# FINAL DRAINAGE PLAN

## CREEKSIDE AT LORSON RANCH FILING NO. 1

**Engineering Review**

EPC Planning & Community  
Development Department

SHEET NUMBER: **1**

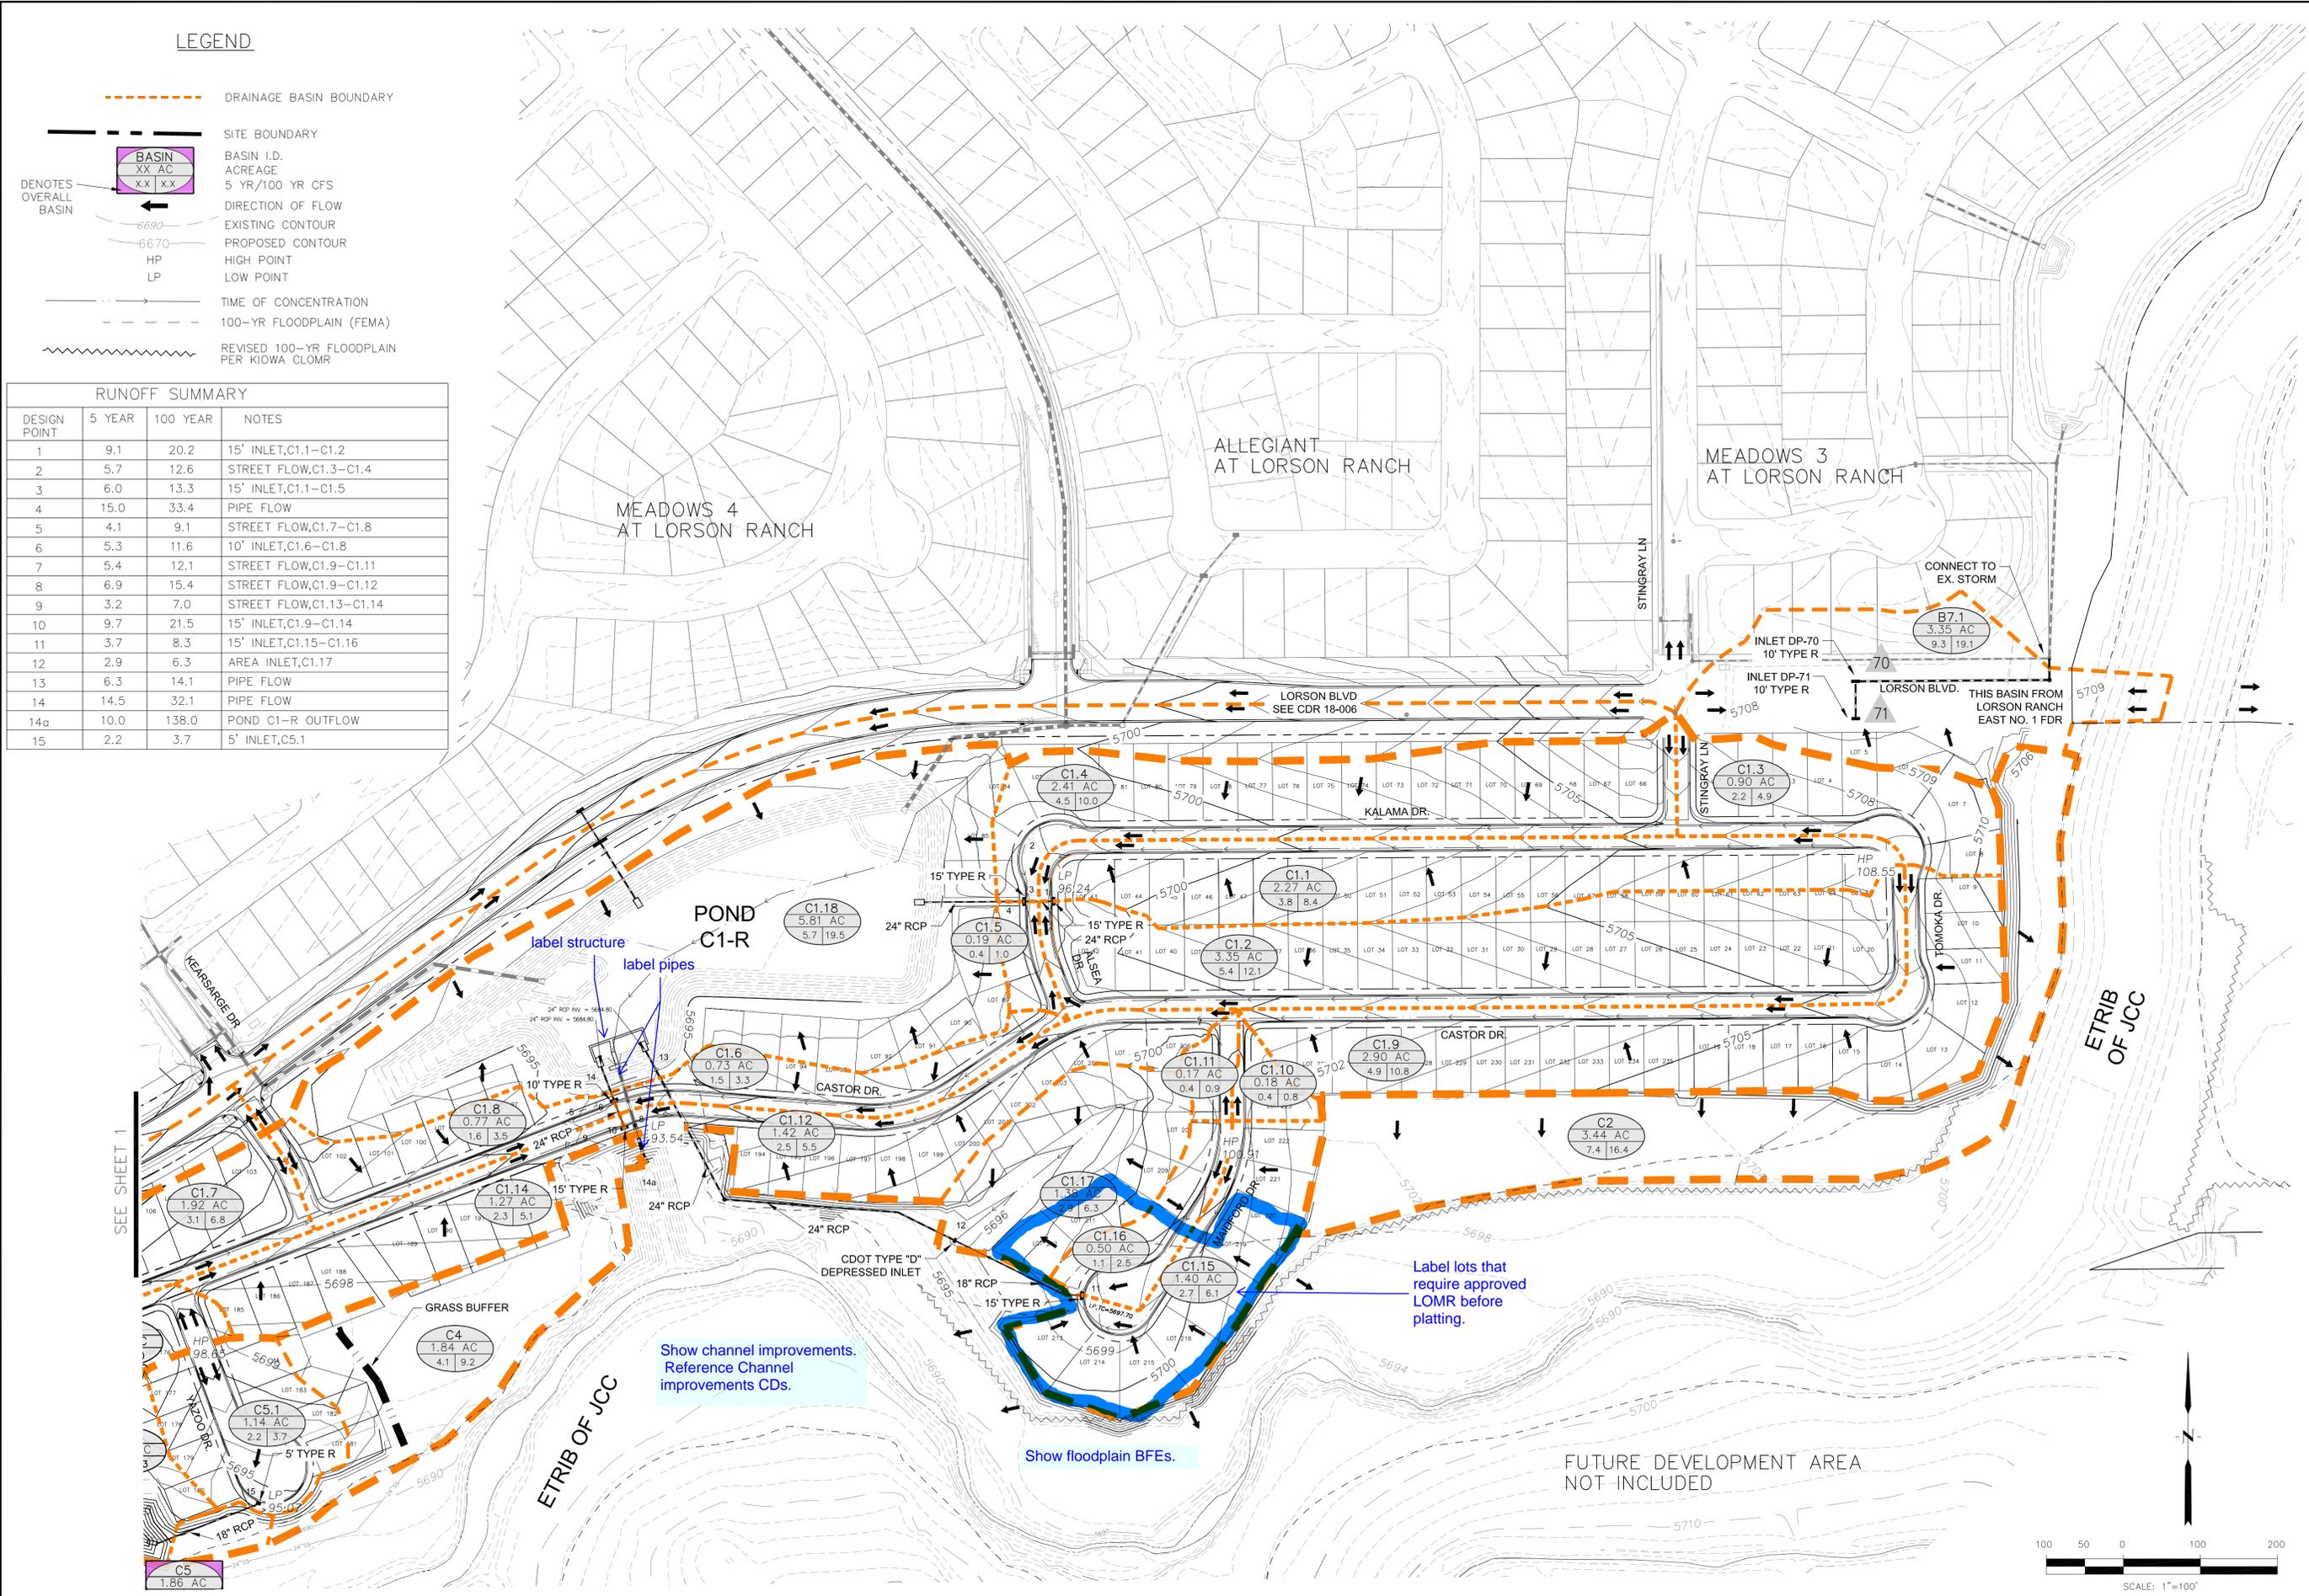
Show floodplain BFEs.
